Re: Planning Application Consultation - Application Ref: 2016/5052/P Flat A, 95 Torriano Avenue, London, NW5 2RX Erection of rear outbuilding following excavation to rear garden area

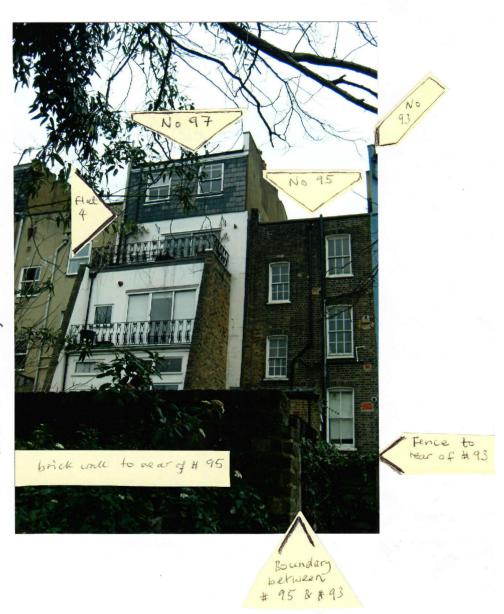
Please find attached site photos relating to the above application. I am sending them directly to your email address as it is not possible to attach photos to comments made on the Camden website.

## photo sheet 1

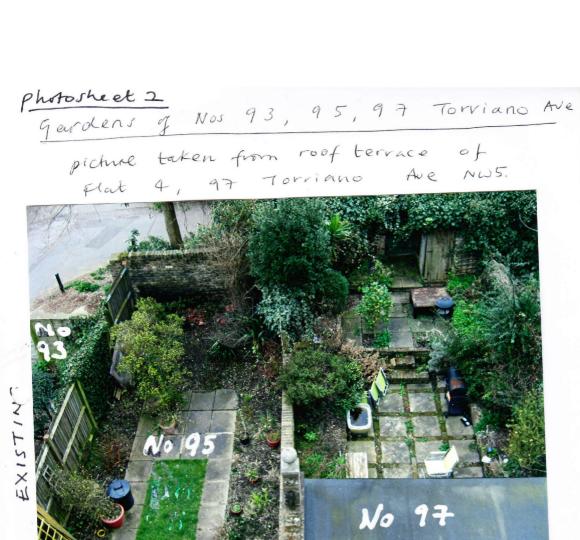
Rear of Torriano Ave NW5, Nos 97-95-93 (at edge of pic) Picture taken from Torriano Mews.
